# Intel® 6300ESB I/O Controller Hub (ICH)

Specification Update

*October 2007*

**Figure 1. Board Workaround for PCI-X Secondary Bus Reset Functionality**

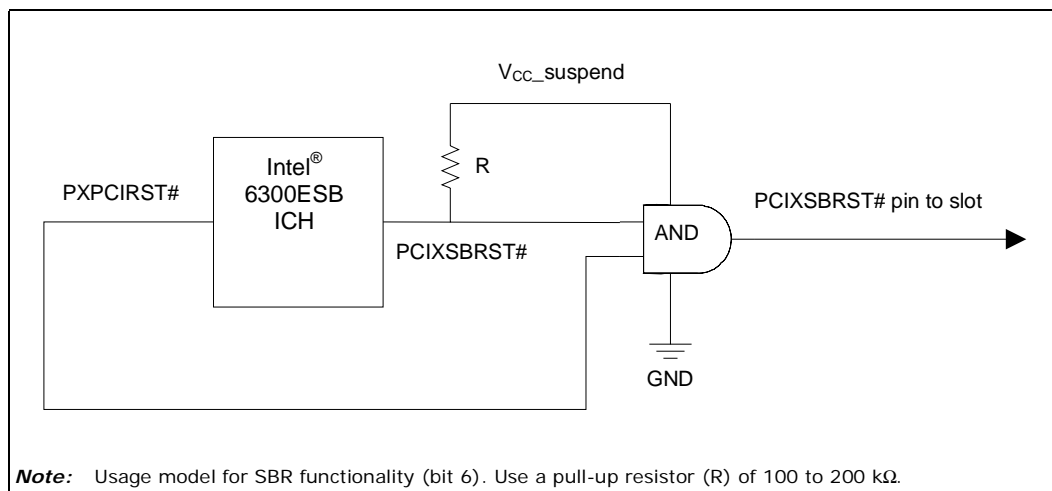
### 1. Board workaround for PCI-X secondary bus reset functionality

**Problem:** The Secondary Bus Reset pin (PCIXSBRST#) on the PCI-X bus is internally tied to the Vcc\_core well. When the system goes into S3 state (sleep), this signal is floating due to Vcc\_core going away.

**Implication:** System will not WOL when PCIXSBRST# is connected directly to the PCI-X slots.

**Workaround:** A board workaround pulls the PCIXSBRST# pin up to Vcc\_suspend through a resistor (R). This pin is also ANDed with the PXPCIRST# pin so that if the PCI-X bus resets, the signal that is routed to the slot reflects the reset. Also, since the AND signal is powered by Vcc\_suspend, when the system goes into sleep state (S3), this voltage is still present and the correct voltage is applied to the signal that is routed to the slot. See Figure 1 below.

**Status:** No fix. This board workaround is to be used if customers plan to utilize this SBR feature. If not, the PCIXSBRST# pin is to be not connected.
